Public Works Department – Engineering Division

ADDENDUM NO. 4

PROJECT 5067 WTP FILTER IMPROVEMENTS AND HYPOCHLORITE CONVERSION

DWG. NO.
C102

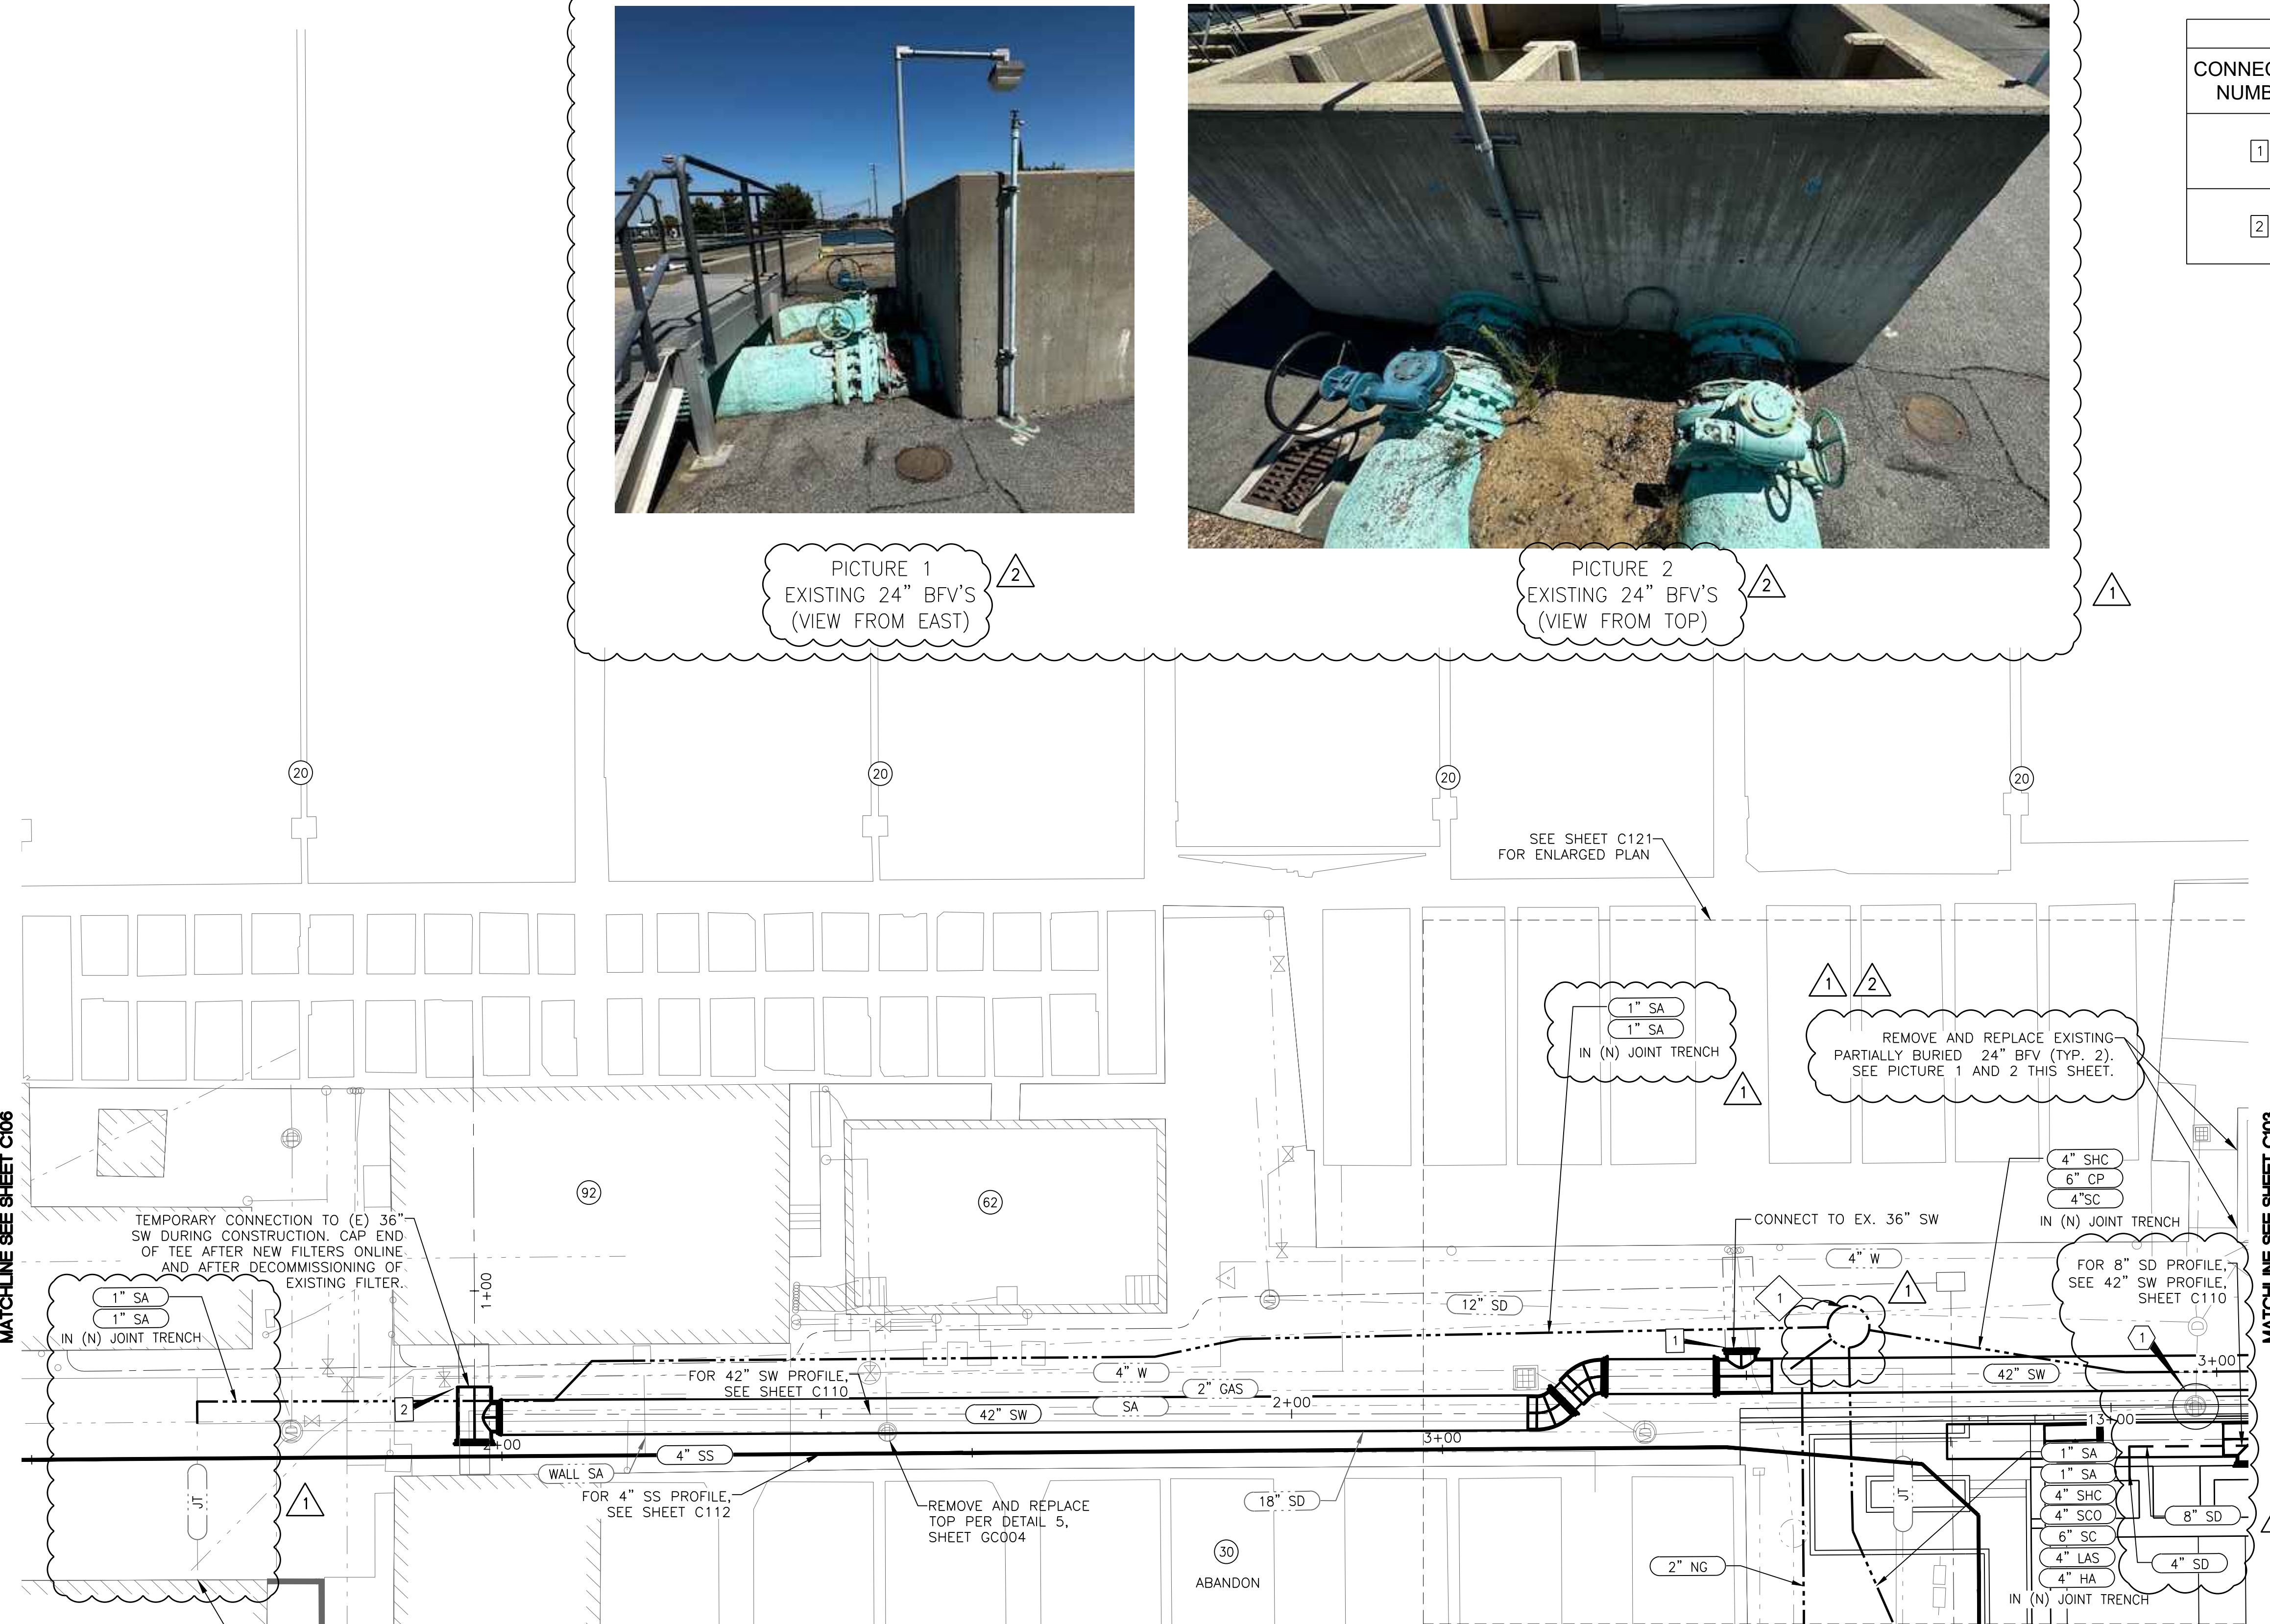
21. Remove all references to wet testing in Specification 41 22 13.13.
22. Replace Drawing C102 with the attached updated drawing C102.
23. Replace Drawing S301 with the attached updated drawing S301.

56. The Addenda #3 Drawings C102 and C103 shows three 18" Butterfly Valves to be removed and replaced at the existing Flow Splitter Box. Drawing sheet 2M-1 on the reference file "Ref Mat A3 1988 CDM Dwgs" shows three 24" Butterfly Valves at the Flow Splitter Box. Please confirm the size of these Butterfly Valves.

Response: Please see revised sheets C102 and C103 in this addendum, Items A.13 and A.22.

**WATER TREATMENT PLANT
FILTER IMPROVEMENTS AND
HYPOCHLORITE CONVERSION**
YARD PIPING PLAN (AREA 2)

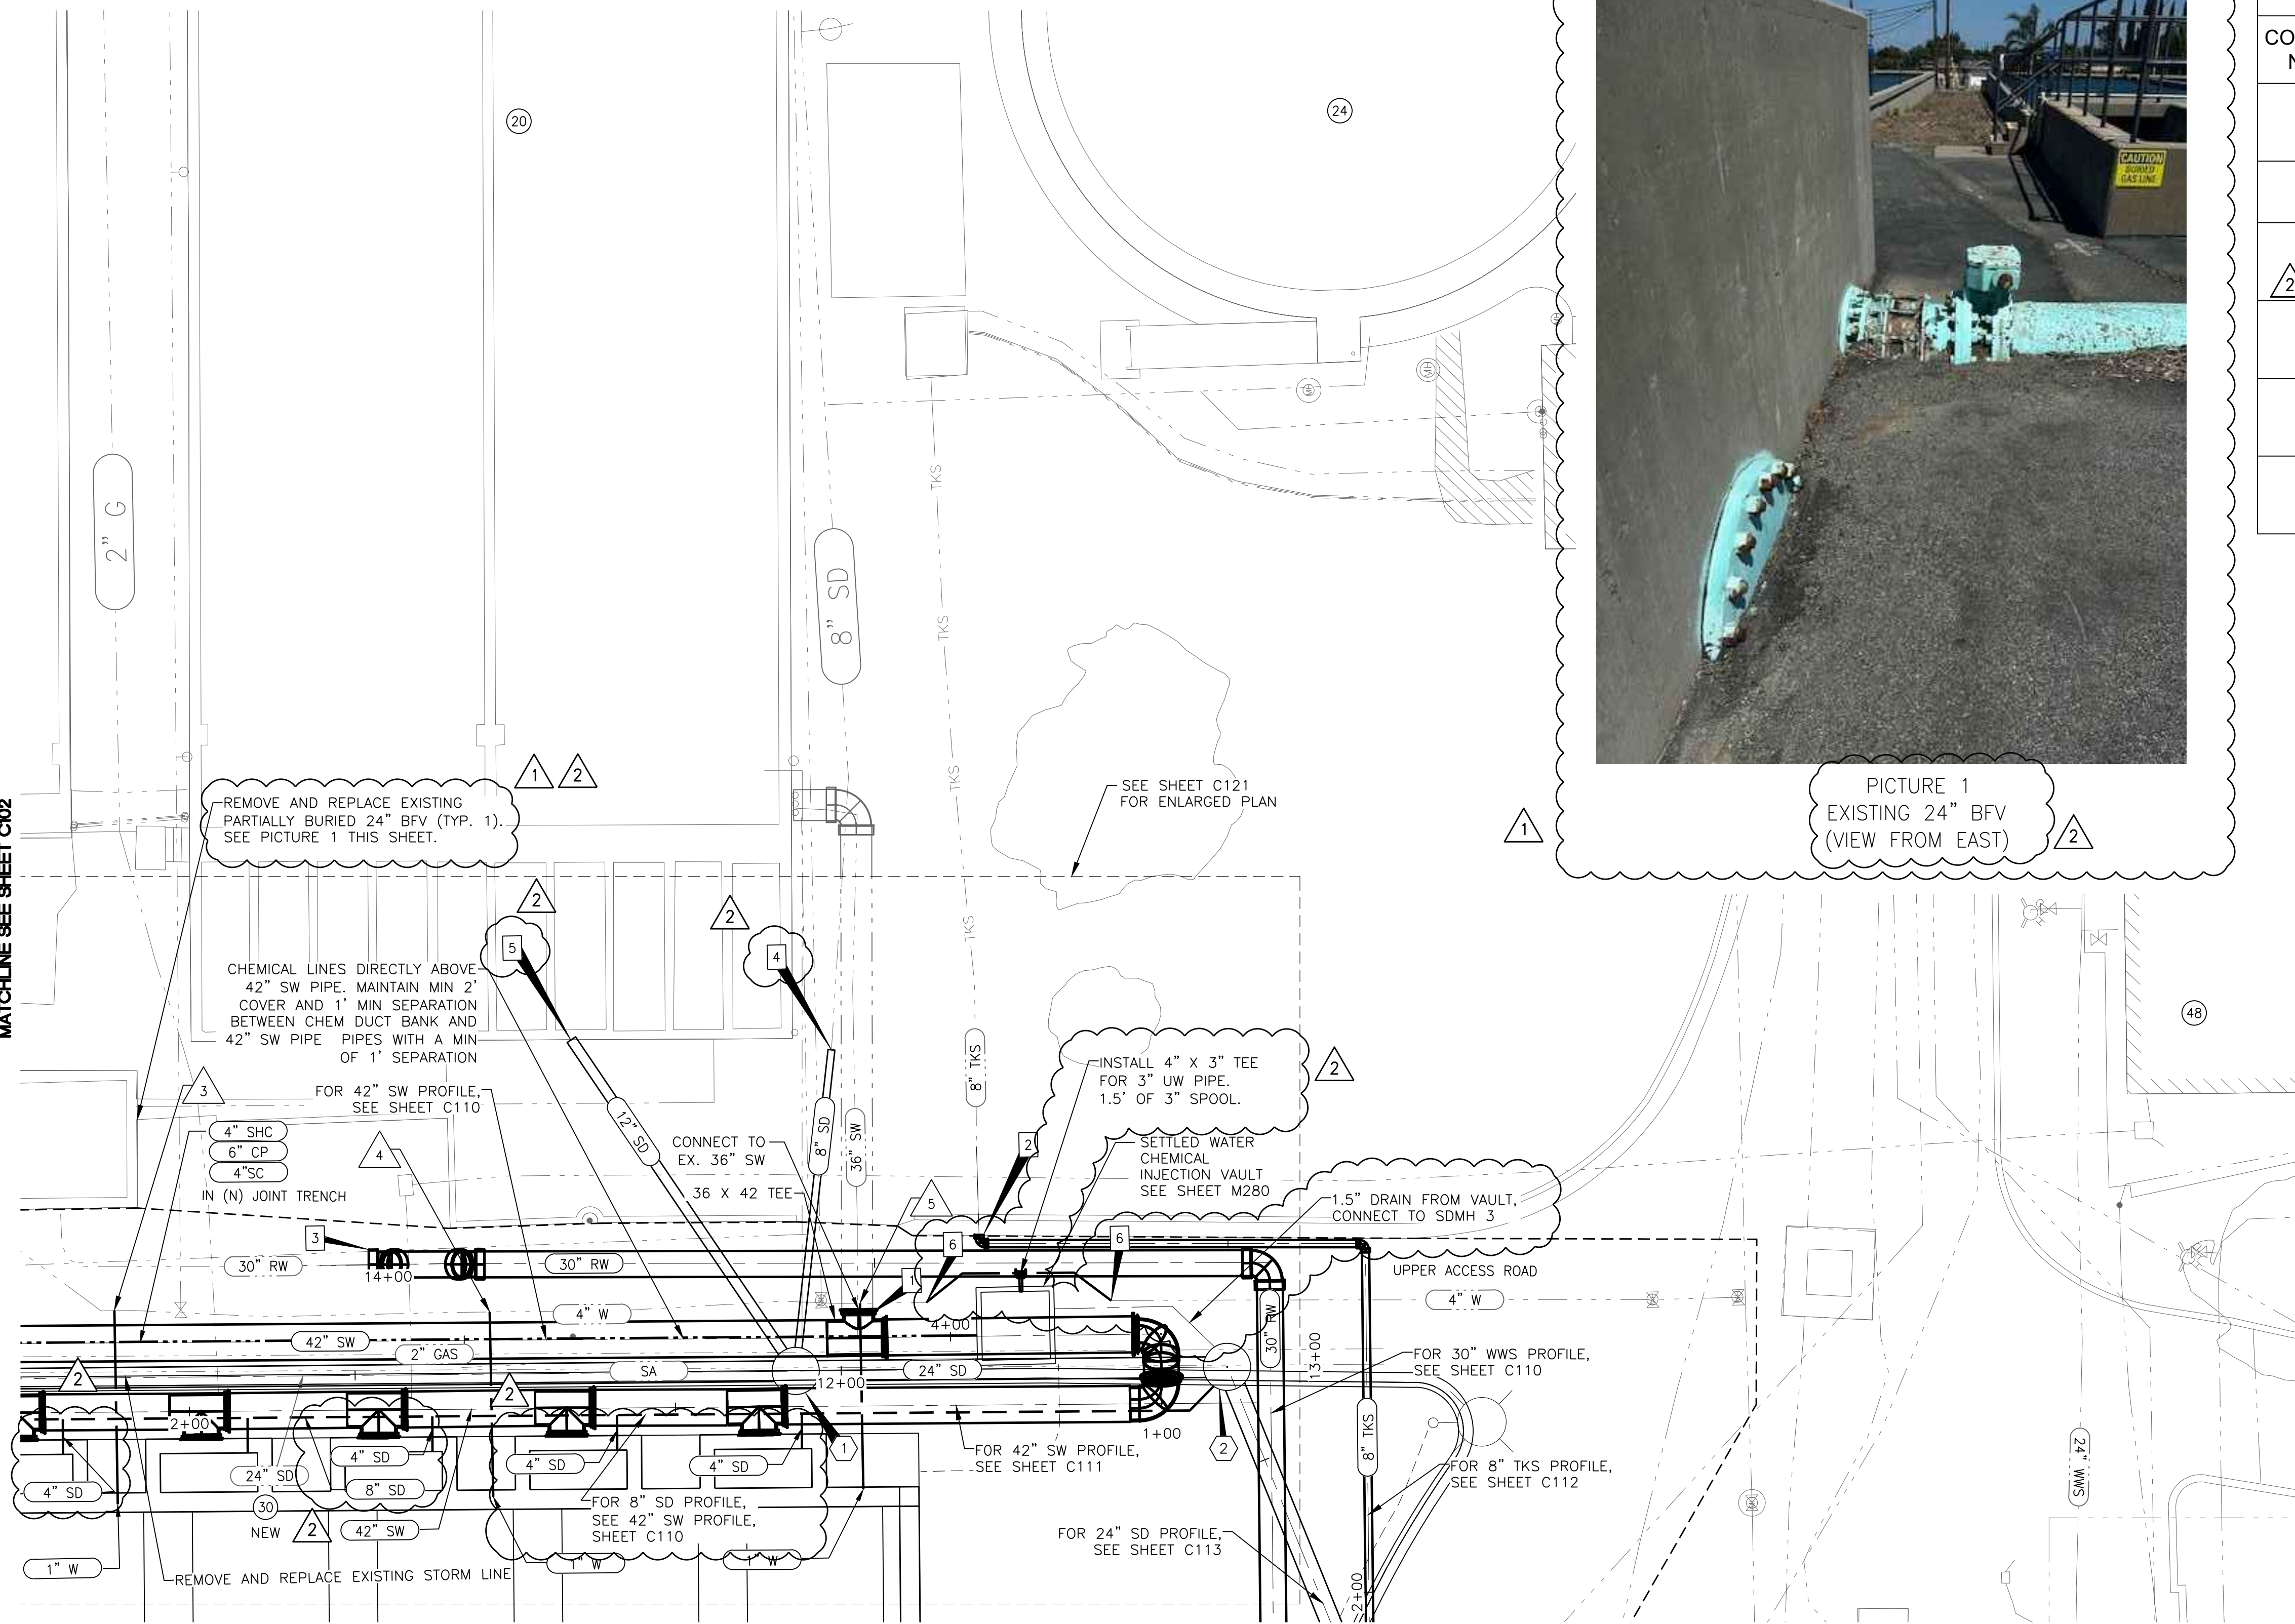
13. Replace Drawing C103 with the attached updated drawing C103.
14. Replace Drawing S308 with the attached updated drawing S308.
15. In Section 40 05 10, Part 2.2.N.1.b, add the following "Steel Plate Fabricators Association (SPFA) Quality Certification Program for Steel Pipe and Accessory Manufacturers, or the Lloyd's Register Quality Assurance" after "...shall conform to the requirements of ANSI/AWWA C200 and ISO 9001:2005 Certificate of Quality System Registration"

10. Where is the 3" UW line on the overall site plans from the settled water chemical injection vault?

11. Where is the 1.5" drain line on the overall site plans from the settled water vault on sheet M280? Did not see this manhole on any of the site plans. I see SDMH 4 on sheet C105, but you have SDMH S4.

12. Where is the 8" drain and all of these 4" drains? They are not shown on any of the site plans. Please advise.

Response: Sheet C103 has been revised. Please see Item addendum, Item A.13.

Response: Sheet C103 has been revised. Please see this addendum, Item A.13.

Response: 8" Drain line runs below the 42" SW. 4" and 8" drain line has been added to plan views. See revised sheets C102 and C103 per this addendum, Items A.13 and A.22.
